SUPPLEMENTARY RESPONSE TO SUBMISSIONS REPORT 2

ALEX AVENUE PUBLIC SCHOOL_SSD_9368

Associate Director	Alaine Roff
Consultant	Christopher Croucamp
Project Code	P4090
Report Number	Supplementary RTS Report 2 – Final

Figure 2 – Comparison of Ground Floor Plan (as submitted with SRTs 1) and the Amended Ground Floor Plan

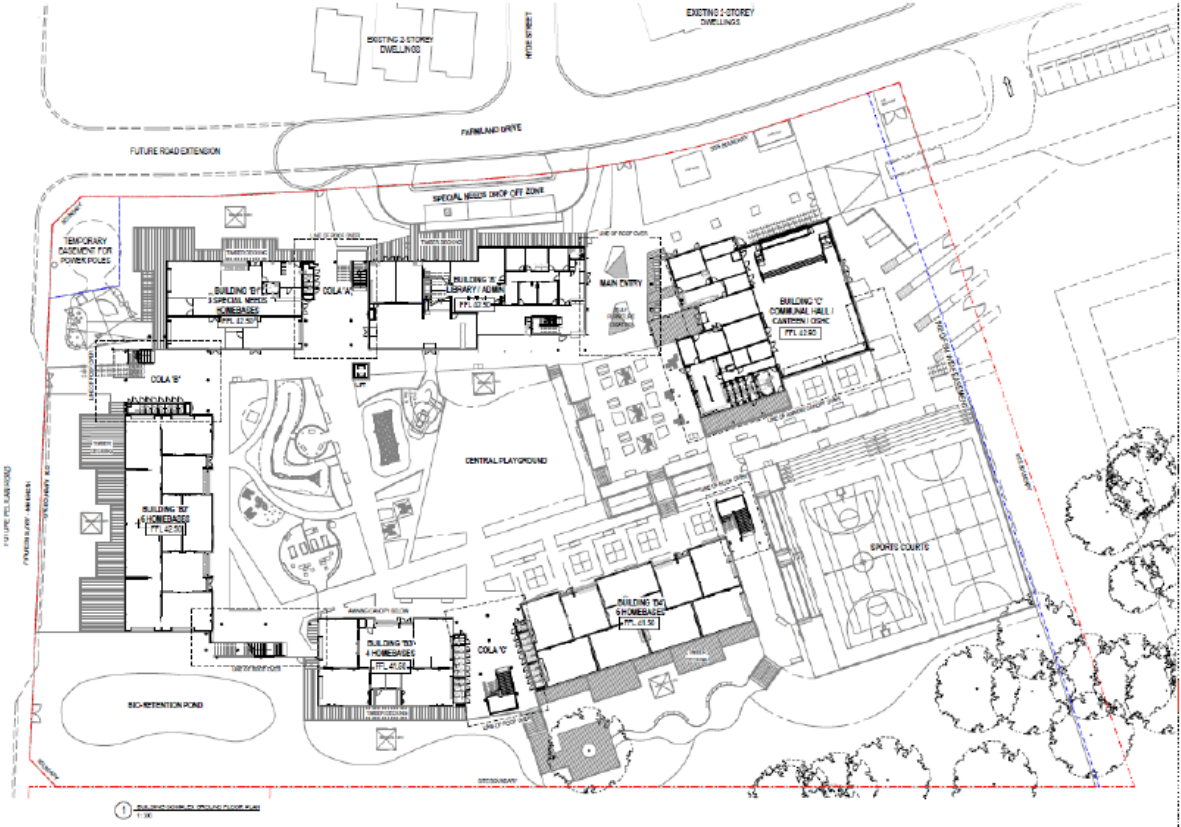
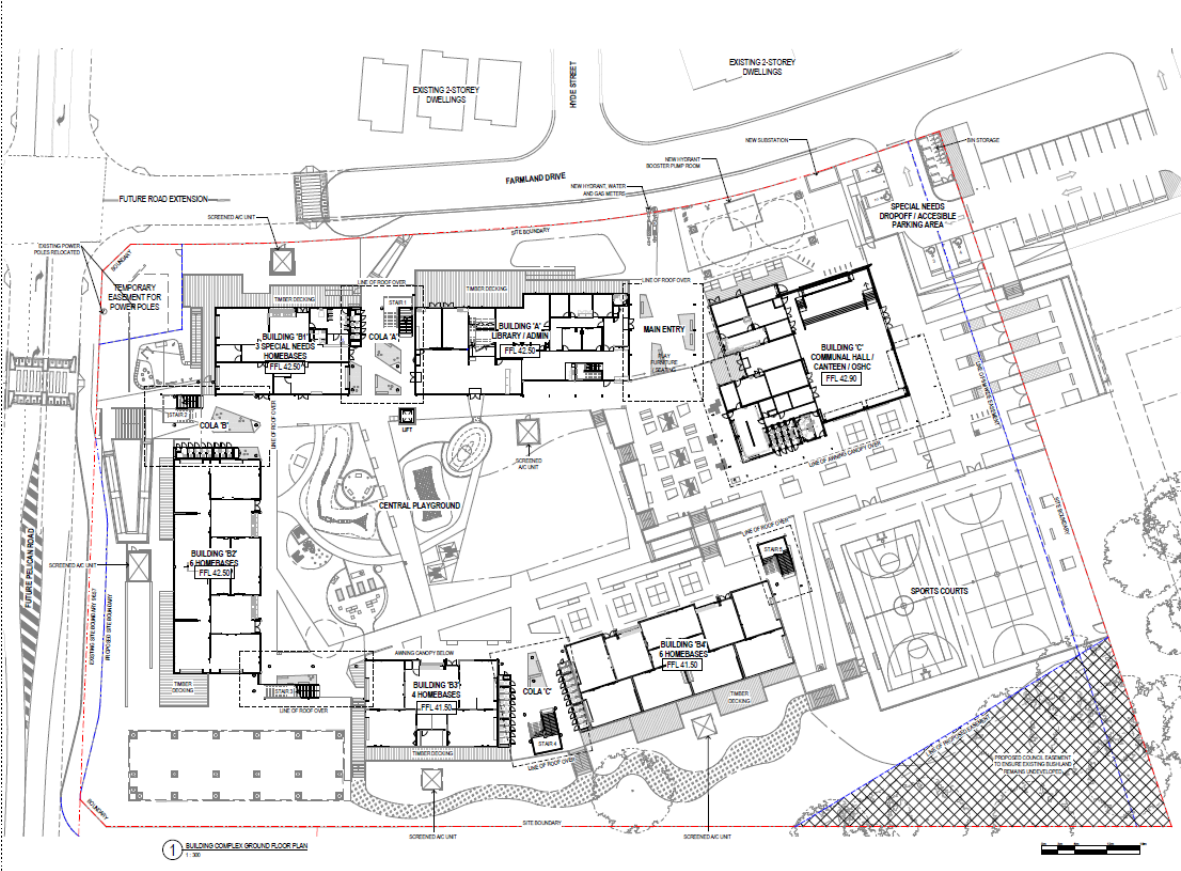
In accordance with Section 55 of the EP&A Regulations, the proposal seeks to make a series of amendments to the proposed development. The amendments are a result of ongoing detailed design development and in response to agency submissions. The following amendments to the previous design are proposed:

- Inclusion of a new wombat crossing on Pelican Road.
- Length of bus bay on Pelican Road has been reduced from 44m to 35m.
- Special needs drop off area has been relocated from the Farmland Drive frontage to north east portion of the site resulting in a change to landscaping along the Farmland Drive frontage.

Figure 3 – Stage 1 Plan with Temporary Carpark

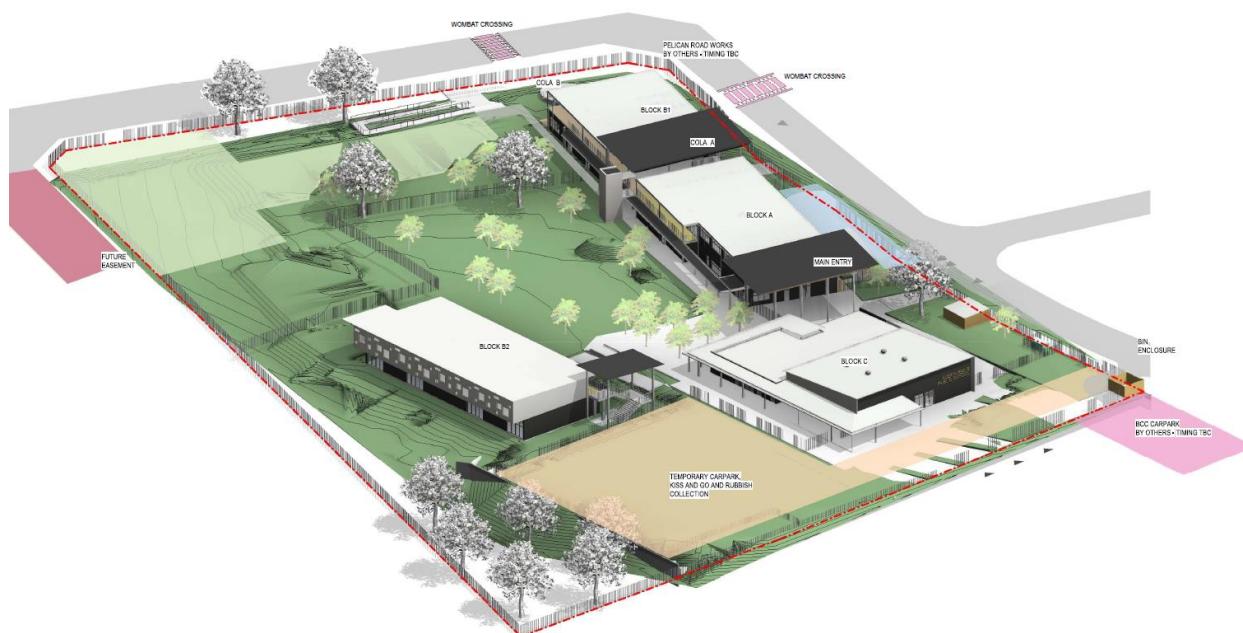
Commencement of construction of Stage 1 is anticipated in 2020, for the school to open Day 1, Term 1, 2021. The timing of the delivery of Stage 2 is yet to be confirmed. Completion of Stage 1 construction works is reliant on the Pelican Road network, Easement B and Council carpark all being constructed, as well as the extinguishment of Easement A. For further details relating to Stage 1 of the phasing of construction and operation, refer to **Figure 3** and the 3D Staging Plans provided at **Appendix T**.

Figure 5 – Proposed Temporary Car Park Arrangement for Stage 1

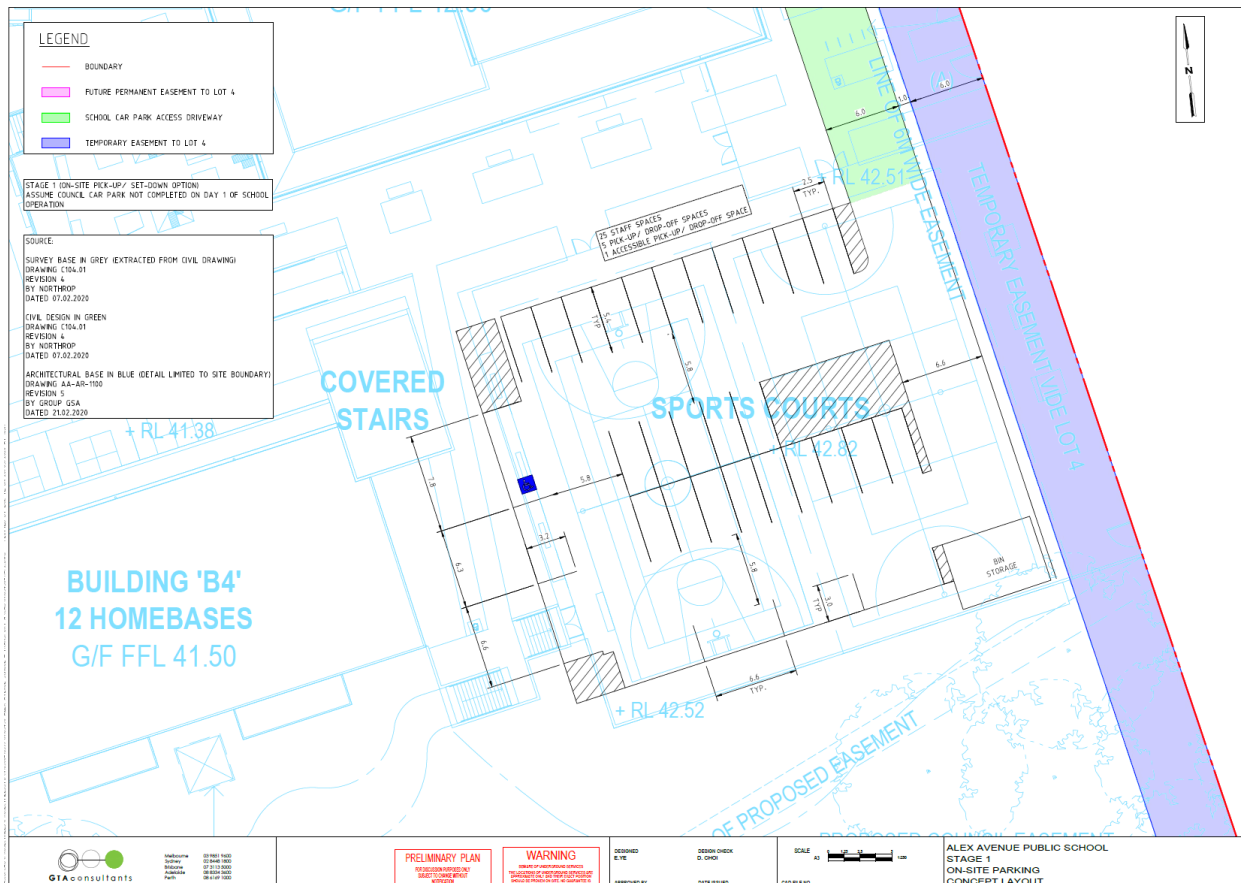
The amended proposal provides a location for temporary onsite staff car parking and drop-off/pick up zone for Stage 1 of the School's operation. Refer to the amended Architectural Plans provided at **Appendix A** for further details. The temporary car park will only be needed if Council does not construct the adjacent car park in time for School opening. It will contain 25 staff car park spaces, 1 accessible parking space, and a drop-off and pick-up zone capable of accommodating up to five (5) vehicle at any time. The temporary carpark, if required, will be located towards the eastern boundary of the site as shown in **Figure 5** (roughly within the area of the proposed sports courts). It will also accommodate a provisional waste storage area until the temporary Easement A is extinguished, and the bin area can revert to its location near the Farmland Drive frontage.
